JAMES A. FITZPATRICK NUCLEAR POWER PLANT

AMENDMENT TO FACILITY OPERATING LICENSE

Amendment No. 49  
License No. DPR-59

ATTACHMENT TO LICENSE AMENDMENT NO. 49

FIGURE 3.5-7 MAXIMUM AVERAGE PLANAR LINEAR HEAT GENERATION RATE (MAPLHGR) VERSUS PLANAR AVERAGE EXPOSURE

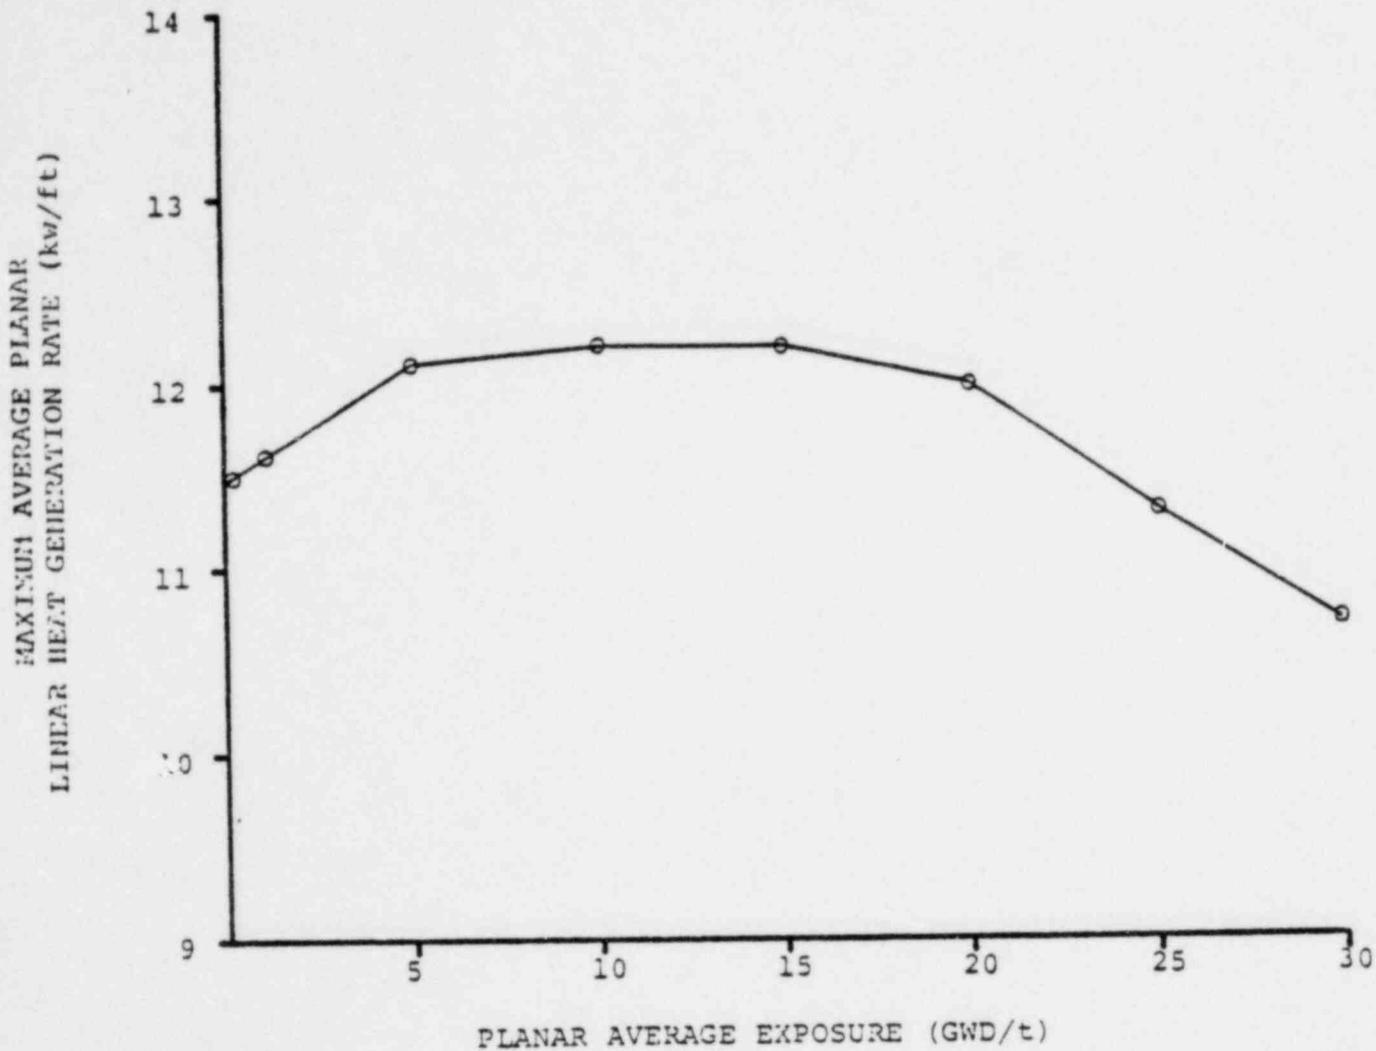
The APLHGR for each type of fuel as a function of average planar exposure shall not exceed the limiting value shown in Figures 3.5.1 through 3.5.8. If anytime during reactor power operation greater than 25% of rated power it is determined that the limiting value for APLHGR is being exceeded, action shall then be initiated within 15 minutes to restore operation to within the prescribed limits. If the APLHGR is not returned to within the prescribed limits within two (2) hours, an orderly reactor power reduction shall be commenced immediately. The reactor power shall be reduced to less than 25% of rated power within the next four hours, or until the APLHGR is returned to within the prescribed limits.

are within the 10 CFR 50 Appendix K limit. The limiting value for APLHGR is shown in Figure 3.5.1 through 3.5-8.
